Technical BULLETIN

RECALL This modification has top priority. This bulletin must be performed immediately to ensure customer safety.

2001~2003 XV16 MODELS FACTORY MODIFICATION CAMPAIGN

Main Shaft Modification:

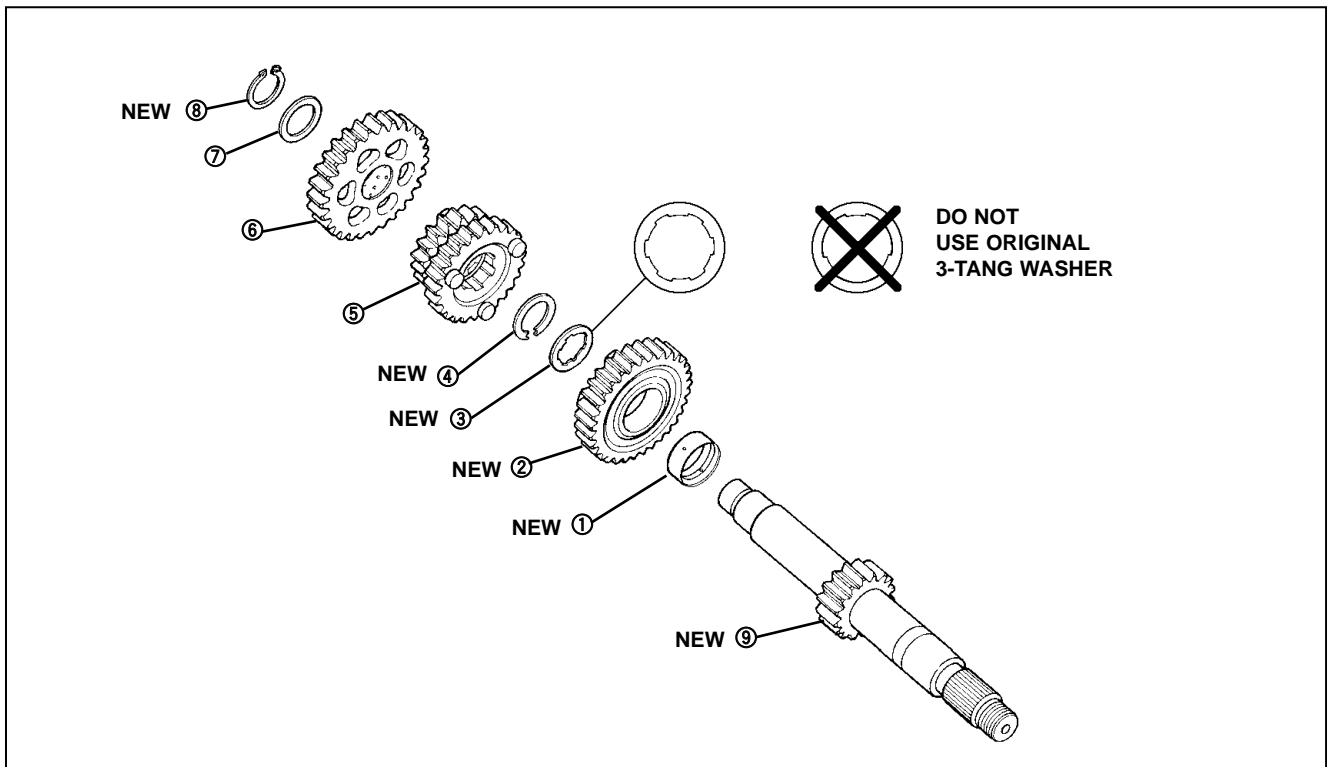
- Completely disassemble the main shaft. The Washer ⑦, 5th Pinion Gear ⑥, and 2nd/3rd Pinion Gear ⑤ will be reused.
- Install the components on the new-type Main Shaft ⑨ in the following order. Lubricate all components with engine oil. Be sure circlips are installed with the sharp edge of the inner diameter facing away from the mating washer.

Be sure to use all of the new parts in the kit. Otherwise, the transmission can still fail. Be sure that you are installing the new washer ③. It is thicker than the original and can be easily identified by its six tangs on the inner diameter instead of the three on the original washer.

- ① Collar – NEW
- ② 4th Pinion Gear – NEW
- ③ Washer – NEW
- ④ Circlip – NEW
- ⑤ 2nd/3rd Pinion Gear – Reuse original part
- ⑥ 5th Pinion Gear – Reuse original part
- ⑦ Washer – Reuse original part
- ⑧ Circlip – NEW

Drive Shaft Modification:

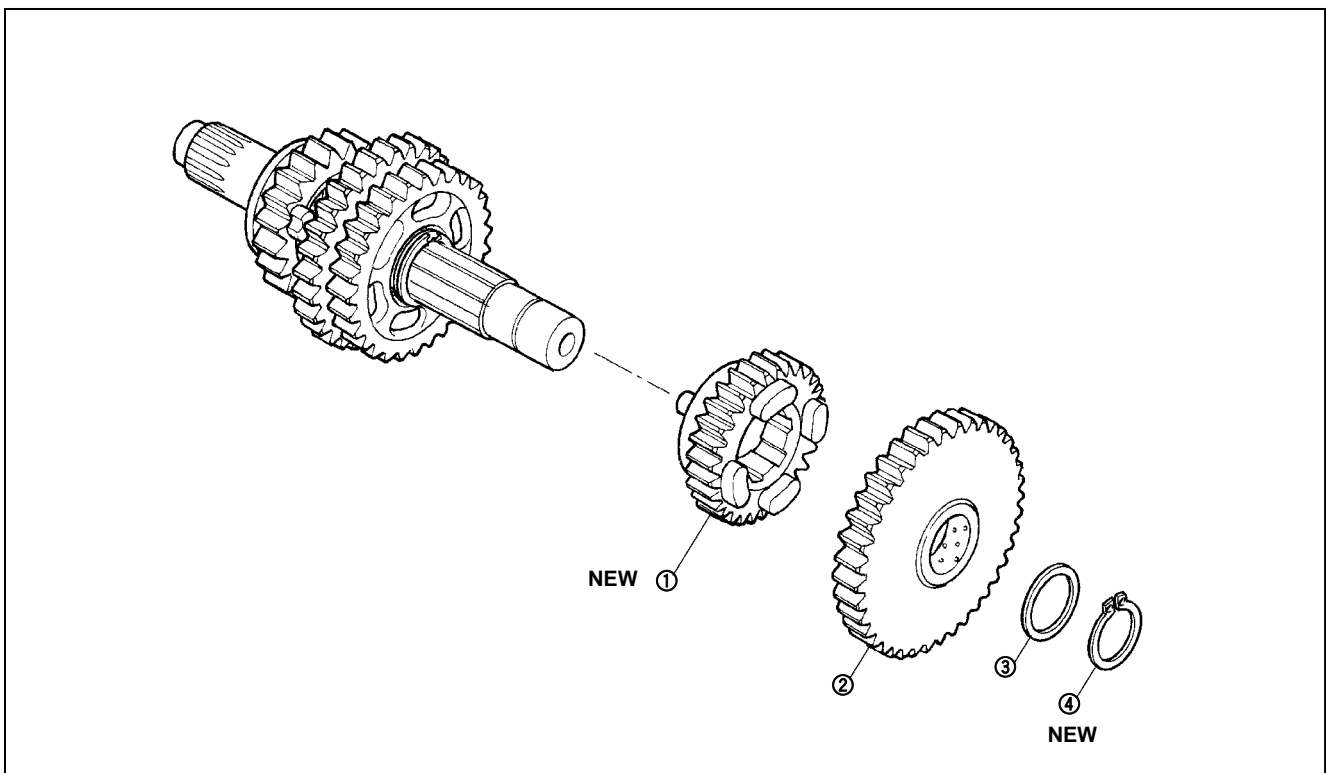
- Remove the circlip and washer from the Drive Shaft, then remove the 1st Wheel Gear and the 4th Wheel Gear. Do not disassemble the rest of the components on the shaft.
- Install the components on the original Drive Shaft in the following order. Lubricate all components with engine oil. Be sure the circlip is installed with the sharp edge of the inner diameter facing away from the mating washer.

Be sure to use all of the new parts in the kit. Otherwise, the transmission can still fail.

- ① 4th Wheel Gear – NEW
- ② 1st Wheel Gear – Reuse original part
- ③ Washer – Reuse original part
- ④ Circlip – NEW

IDENTIFICATION PROCEDURE

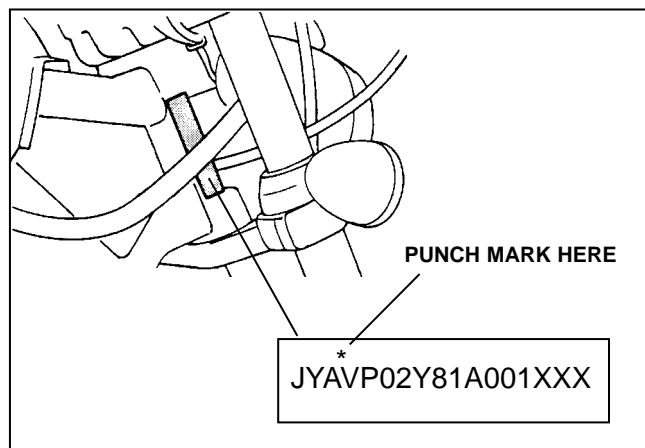
After modifying a unit, make a punch mark above the frame number (VIN) on the steering head pipe as shown in the illustration below.
